## **London Resort Consultation Response**

**Thames Crossing Action Group** represents thousands of people who are strongly opposed to the proposed Lower Thames Crossing. We object to the proposed Lower Thames Crossing for many different reasons and do not consider the project to be in any way fit for purpose.

**LR PEIR Fig 9.2 Highway Traffic Model Extent -**

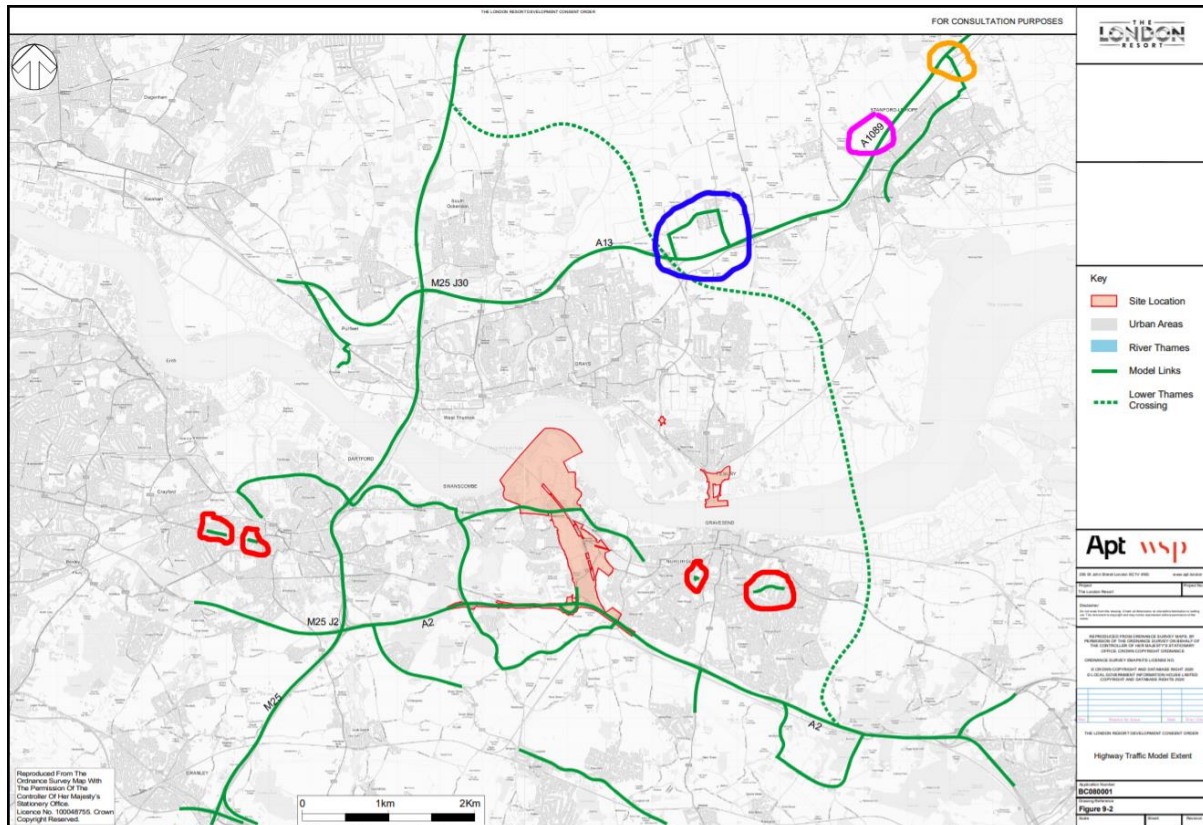
This document is incorrect as you have the A13 near Stanford-le-Hope labelled as the A1089 (circled in pink on the image above). Considering that the A1089 is the route you are proposing traffic access the proposed parking facility in Tilbury this is very misleading and poor performance from LR to not even be able to identify and label it correctly on a map.

In addition the actual A1089 is not even marked in green on the map, which is supposed to show model links. Again considering traffic will have to use the A1089 to access the parking facility in Tilbury this is unacceptable and very concerning that you have failed to include it.

There are also routes marked in green that do not make sense as to why they should be included. Some of the green highlighted routes include very small/short isolated sections, which again make no sense. (We have circled the most random ones in red on the image above.)

We particularly enquired via email about the inclusion of Baker St, High Rd, Rectory Rd in Orsett (circled in blue in image above), and were told, *"These links have been included due*

*to the potential changes in traffic flows along the A13 which could impact upon local communities within the vicinity."*

Since none of these three roads are directly accessible from the A13 this doesn't provide a clear and informative reply. However, it would suggest that if this is the case that other junctions and roads should also be highlighted, simply by fact that they would need to be used to access these roads alone.

When we raised this point via email with you we were told, *"We agree that this link may be used to reach the Tilbury parking facility. We will include this link, along with many others, within the traffic modelling as we progress."*

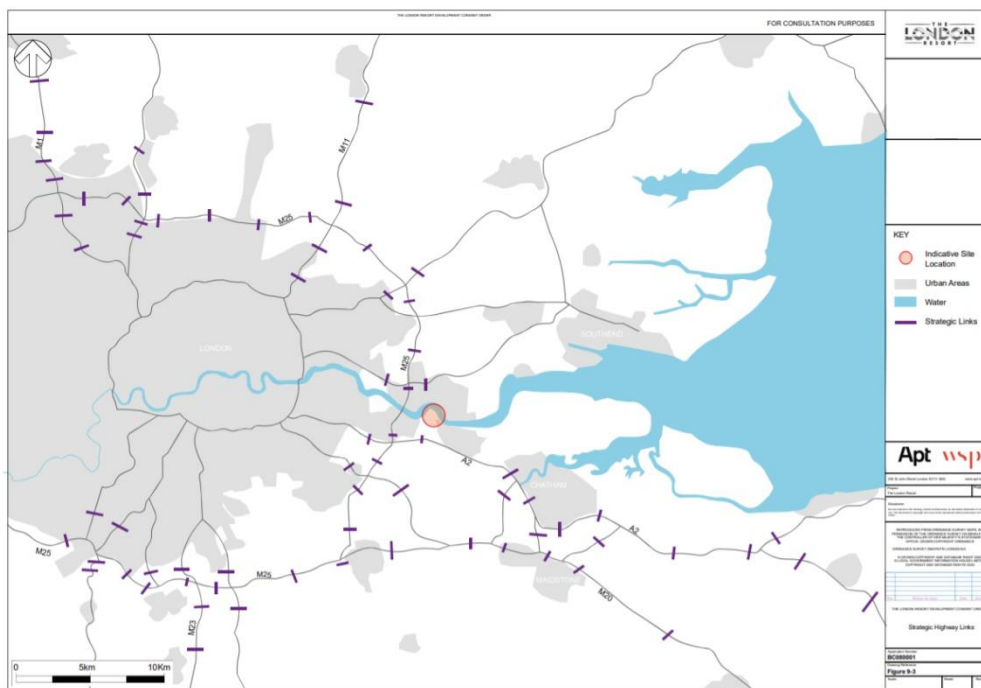
The map used in this document doesn't even clearly show the fact that these roads are not directly connected to the A13.

We can in no way understand why you have highlighted the 'junction' for want of a better word that we have circled in orange. Again this is not a route that is directly accessible from the A13 as your map gives the impression of. It is also a very strange assumption to come to that this route would be impacted, and there is no explanation as to why.

You are including the proposed Lower Thames Crossing in this map, yet you are not highlighting the Stanford-le-Hope junction on the A13. Any traffic attempting to use the LTC (or indeed the Orsett Cock junction of the A13, including the A128 traffic) to access the A1089(south) would all have to detour to the Stanford junction to go up and around the traffic lighted roundabout and head back westbound on the A13 to reach the new proposed joint LTC/A1089(south) junction to access the A1089 southbound to the proposed London Resort Parking facility in Tilbury.

## LR PEIR Fig 9.3 Strategic Highway Links -

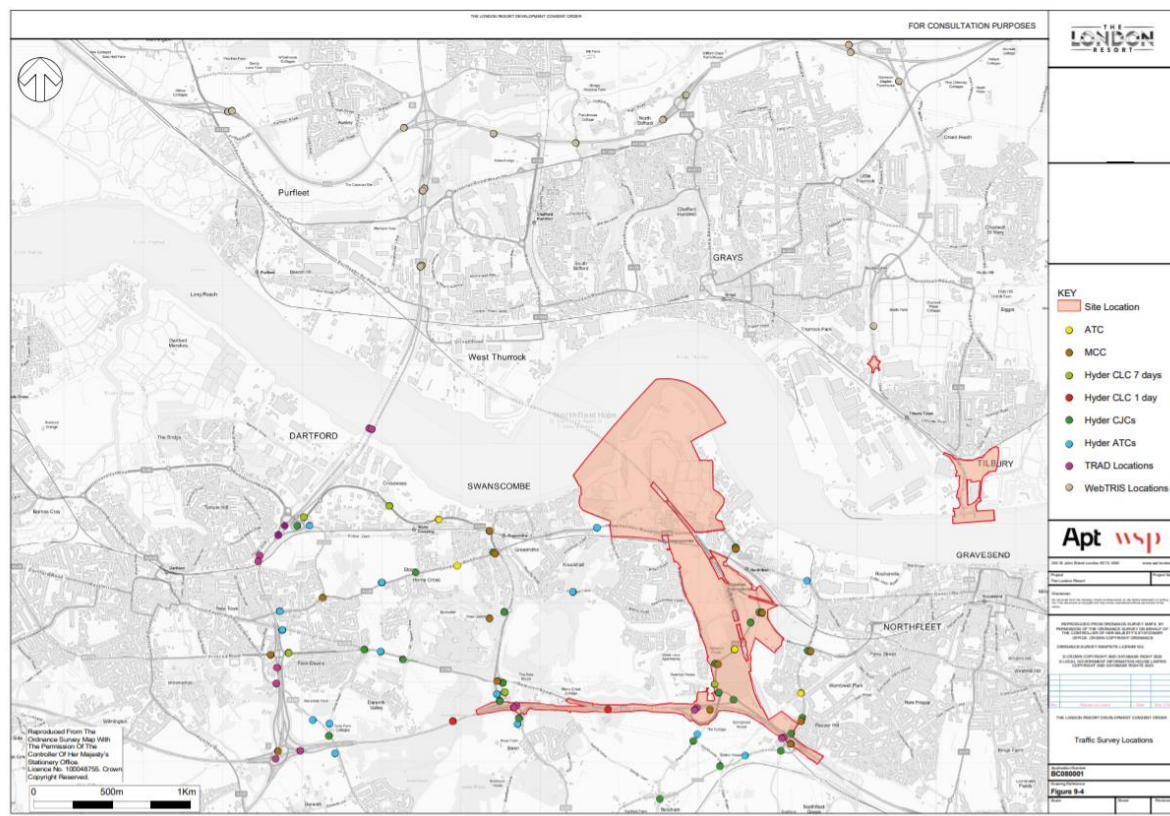
The map above is supposed to show strategic links. How can lines marked on a map without any labelling be considered adequate? It is not even clear whether the A1089 is marked on this map or not. Some of the lines intersect routes, but do not show what junction it is, or indeed even the route which it is on, as only a few random roads are actually labelled.

The proposed parking facility to the north of the river in Tilbury is not even marked on the map either.

Clearly this is not the case as figure 9.3 is an inadequate poorly labelled image which does not provide clear and informative detail that is legally required for an adequate consultation.

**LR PEIR Fig 9.6 Strategic Highway Network –**

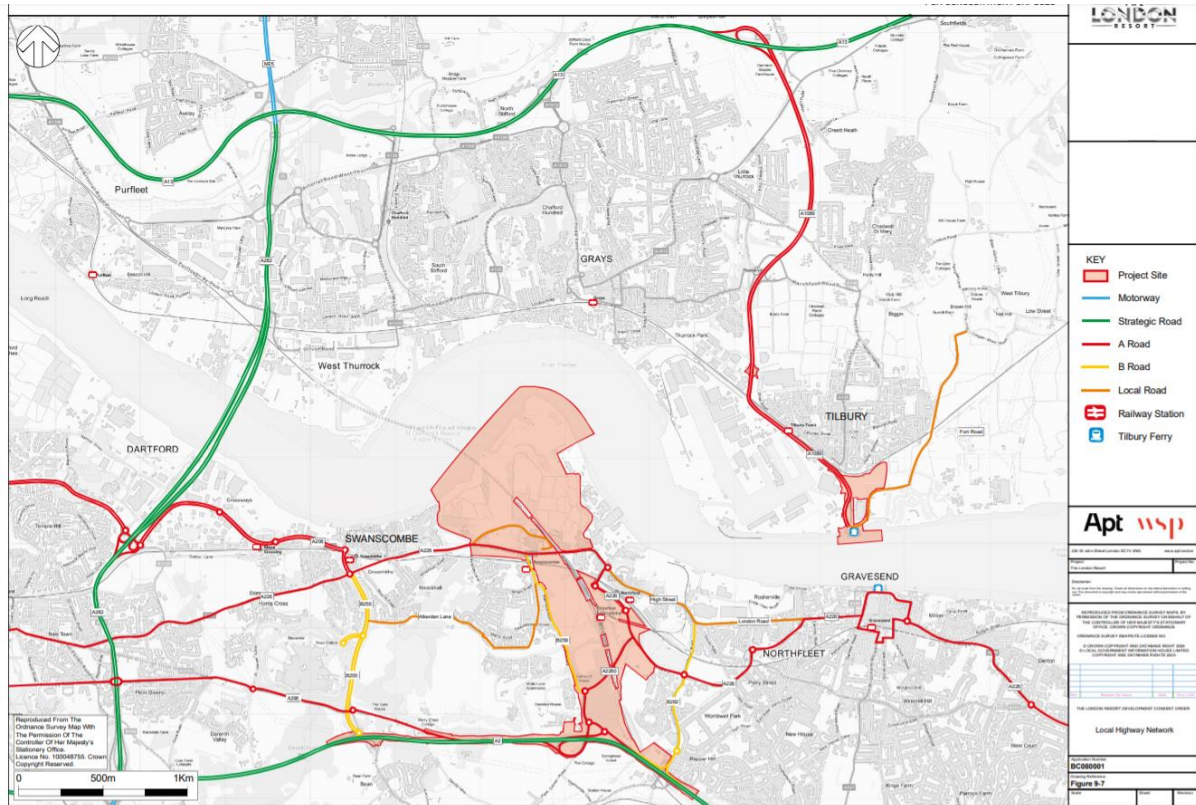
The figure above is supposed to show the Strategic Road Network. However you have glaringly omitted to include the A13 up to the A1089, and the A1089 itself, both of which are part of the Strategic Road Network. Yet another inadequacy of the consultation materials, and proof of lack of clear and informative materials.
